Green Infrastructure Strategy Updates since March 2022 Submission:

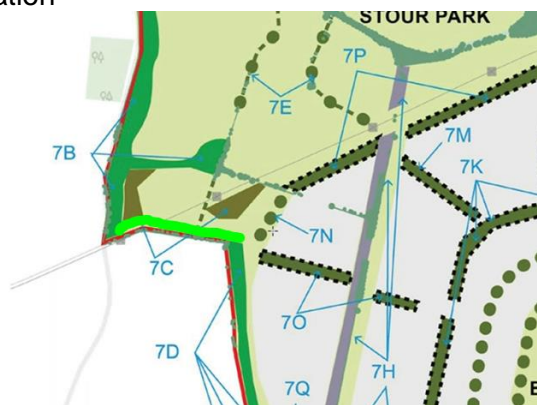
- Diagrams have been adjusted to remove dark corridor to west of Otterpool Manor at this location:
